## PUBLIC HEARING/WORKING SESSION MEMORANDUM

**PETITION #29-21**

**145 Warren Street**

Re: Special Permit – 145 Warren Street

*Topographic Site Plan  
Showing Proposed Conditions at  
#145 Warren Street  
Newton, MA  
Prepared by: VTP Associates Inc.  
Dated: November 4, 2020  
Revised: January 20, 2021  
&  
Turning Radius Plan  
Prepared by: VTP Associates Inc.  
Dated: February 12, 2021*

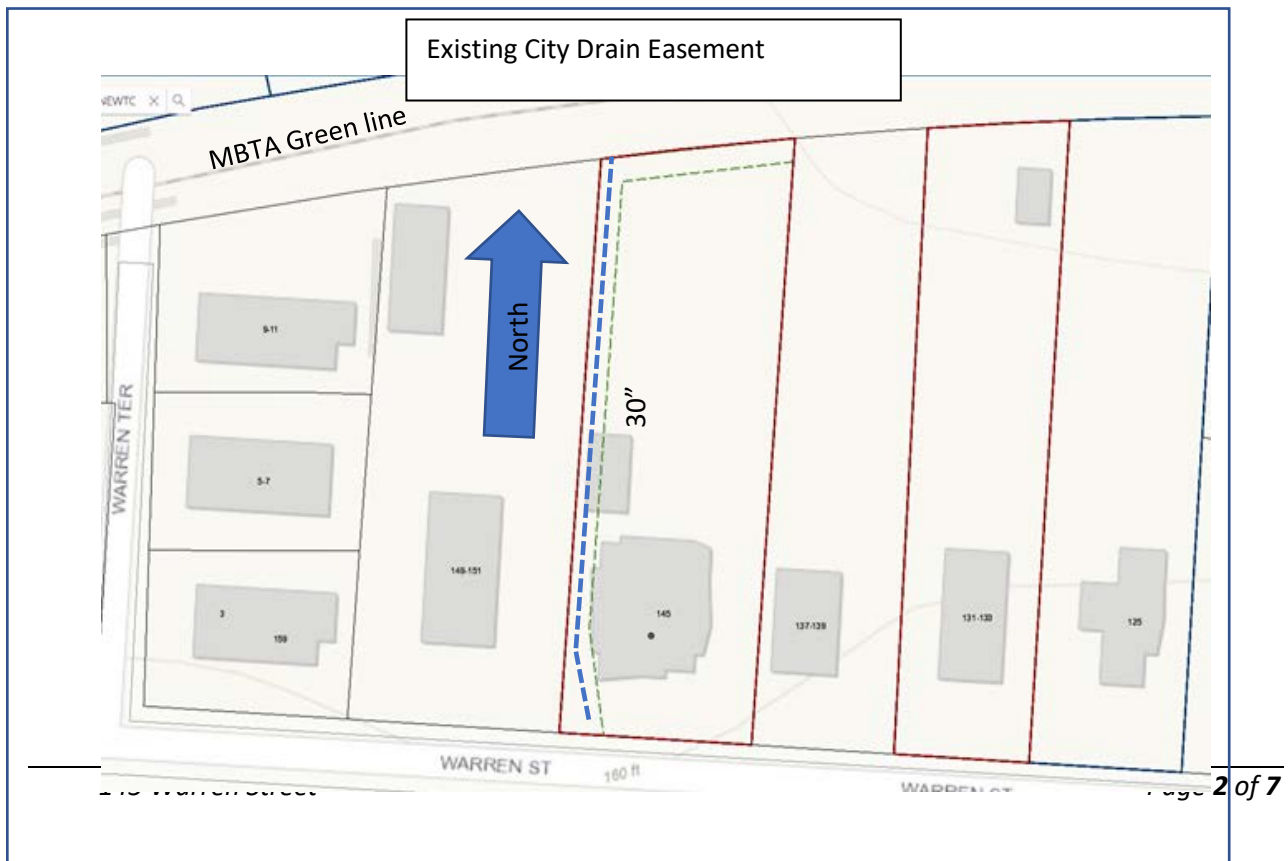
Access to the units, garages and auto court is provided via driveway located near the easterly property line. The driveway has a retaining wall near the property line for a distance of +/- 150-feet and is 6-feet at the high point. Retaining walls over 4 feet high will need a structural engineers design to ensure that the wall does not fail in (overturning, sliding or settlement) along with a safety fence along the top of the wall, detailed analysis including wall drainage and detailed grading and/or section(s), and finished surfaces will be required when applying for a Building Permit with the Inspectional Services Department.

A 10-ft. wide City drain main easement traverses the property along the north and west property lines, a 30-inch drainpipe transmits stormwater from the road collection system through the lot and into the wetlands along the MBTA. The design has a proposed retaining wall located adjacent to the drainage easement; should this application be approved; the actual position of the drainpipe must be delineated with a Closed-Circuit Television and sonic tracer to ensure that the pipe is within the easement and the construction of the proposed retaining wall and/or foundation of the proposed units do not interfere with the pipe. Post construction inspection of the 30" drainpipe via a closed-circuit television (CCTV) will also be required and should be part of any Board Order. Both CCTV inspections must be witnessed by a representative from Engineering.

The engineer of record has designed a drainage collection system consistent with the DPW Stormwater Management Policy that collects and infiltrates the 100-year storm event on site. The design includes four infiltration systems for infiltration of roof and driveway runoff. Test pit #2 indicates standing water at 28-inches (elevation 146.4) the bottom of drain system #3 is at 148.4 which provides the required 2-foot of separation; however, the test pit was conducted on January 28, 2019 it is likely that the seasonal high ground water (SHGW) during the spring season maybe higher. No dewater plan was provided, and a Construction Management plan is needed for evaluation.

System #3 is located in the rear yard, my concern with the siting of this system is the proposed location and long-term maintenance requirement. The Operations and Maintenance [O&M] plan indicates that the system needs to be inspected and cleaned, however; access to this system is difficult at best as it is placed behind the dwelling units, there is no easy access to clean the system. I recommend that this proposed infiltration system be located within the proposed auto-court for easier access. Additionally, system #4 has an overflow that will discharge to the wetlands along the MBTA, this overflow should be eliminated if this system is adjusted. The O&M plan does not include any provisions for bi-annual sweeping of the driveway and auto court, this is needed as it impacts the long-term performance of the infiltration systems.

Municipal utilities will be provided for the three units, additionally the sanitary sewer services will require individual pump systems. The design should incorporate a standby generator for these systems in the event of prolonged power outages since these systems do not have a large storage capacity.

The turning template plan indicates a 2010 BMW 5 Series making maneuvers into and out of various parking stalls, my issue is will the development have a restriction on the type of vehicle that can be accommodated? Different types of vehicles should be study such as a minivan, or SUV. Additionally, on sheets 2 and 3 the BMW is shown making the turns, however; it encroaches into the neighboring stalls that are empty. The plan should be updated to show the other stalls occupied and with various size vehicles then show updated turning movements for various size vehicles.
